HOME 2 SUITES AT ADELL CENTER JSP 22-56

Consideration at the request of Novi Elite Hospitality, LLC for Planning Commission's approval of Preliminary Site Plan and Storm Water Management plan. The applicant is proposing a 5-story hotel with 141 rooms on Unit 5 of the Adell Center Development located north of Grand River Avenue and west of Novi Road. The site plan proposes associated parking and other site improvements. The subject property zoned TC Town Center is part of the Planned Rezoning Overlay (PRO) for Adell Center.

PLAN REVIEW CENTER REPORT

Preliminary & Final Site Plan

BUILDING ELEVATIONS

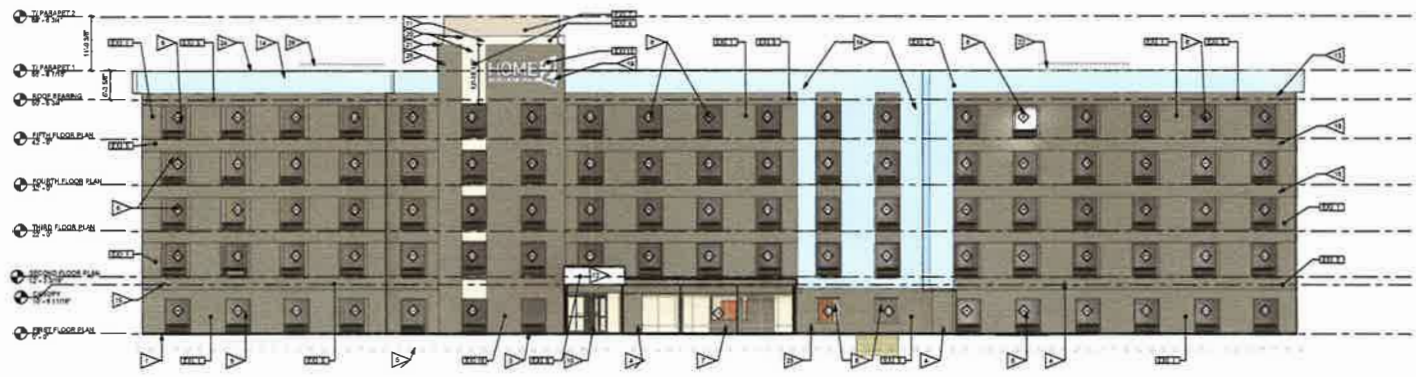
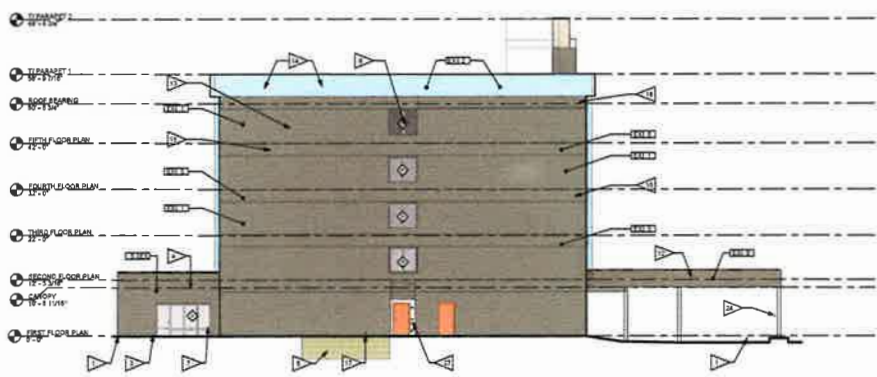
- B. **Section 9 waiver:** Proposed elevations for the hotel building appear to be in full compliance with the façade ordinance. A material Sample Board indicating the color and texture of all proposed façade materials shall be provided not less than 5 days prior to the Planning Commission meeting in order to verify this determination.

A photometric plan has been submitted, and meets the requirements of the Zoning Ordinance except as permitted to deviate as stated above. **Building elevation lighting shall be provided in the revised Final Site Plan submittal.**
